Subject: UniStar Nuclear Energy, NRC Docket No. 52-016
Calvert Cliffs Nuclear Power Plant, Unit 3
Supplemental Response for RAI HS-13

**Supplemental Response for RAI HS-13
CCNPP Unit 3 Environmental Report**

Figure 4.2-1—{Final Site Grading Plan CCNPP Unit 3}

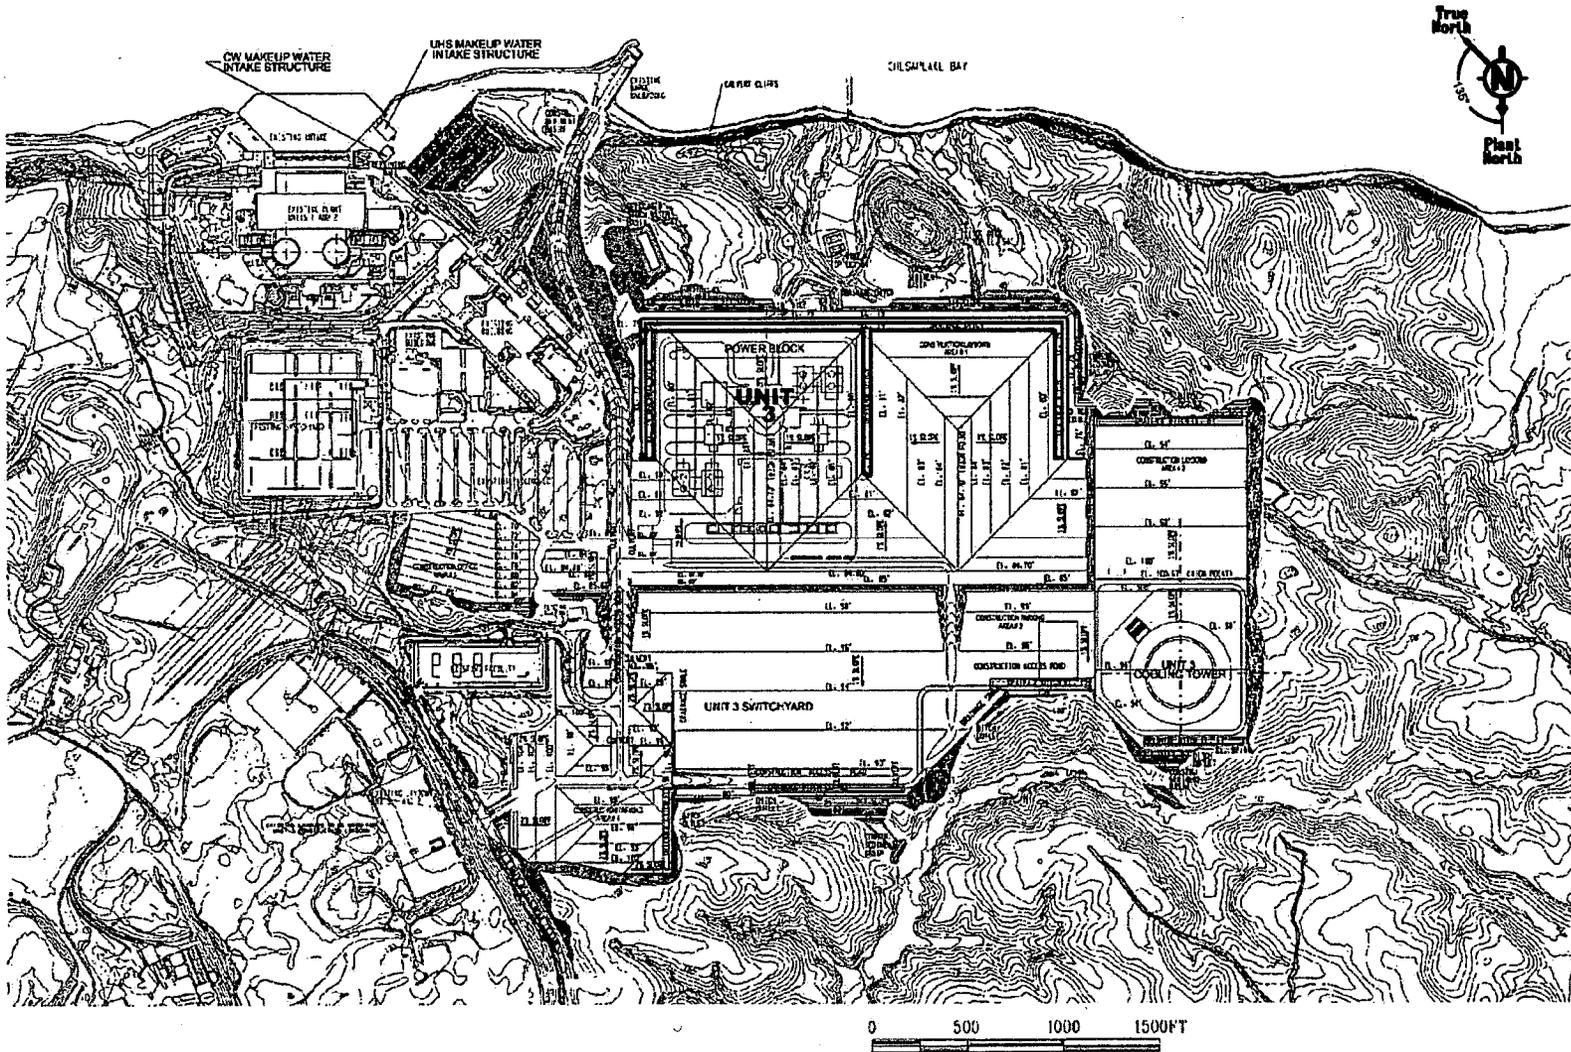
A permanent groundwater dewatering system is not anticipated to be a design feature for the CCNPP Unit 3 facilities. Removal of a portion of the Surficial aquifer during construction may eventually lower the expected depth to groundwater. Surface water controls to minimize precipitation infiltration and the redirection of surface runoff away from the facility area are expected, further minimizing water infiltration to the groundwater system beneath the site. Groundwater elevations will continue to be monitored, and any observed deviations in groundwater elevations potentially impacting the current design basis will be accounted for to design a construction dewatering system, as appropriate (Section 2.3.2.2.11 page 2.3-47). Provide if possible a topographic map with an overlay of the construction foot print and with contours that can be easily read. Describe how the recharge to the Surficial aquifer would be impacted in the short term. Long term is presented in Figures 2.3.2-(24-25). Identify how the seeps and streams would be impacted and how this would impact local wells.

The numerical model of the Surficial aquifer has been revised to evaluate construction impacts to groundwater levels in the vicinity of the power block and stream flow off site in John's Creek. Figure 2.3-86 shows the topography of the post-construction groundwater flow model and Figure 4.2-1 shows the construction footprint of the CCNPP Unit 3 site. Both stream flow and groundwater levels after construction of CCNPP Unit 3 will be dependent upon several factors, including the hydraulic conductivity of the engineered fill material used and the rate of groundwater recharge within the graded area of the site.

The numerical model of the Surficial aquifer has been revised to evaluate construction impacts to groundwater levels in the vicinity of the power block and stream flow off site in John's Creek. Figure 2.3-86 shows the topography of the post-construction groundwater flow model and Figure 4.2-1 shows the construction footprint of the CCNPP Unit 3 site. Both stream flow and groundwater levels after construction of CCNPP Unit 3 will be dependent upon several factors, including the hydraulic conductivity of the engineered fill material used and the rate of groundwater recharge within the graded area of the site.
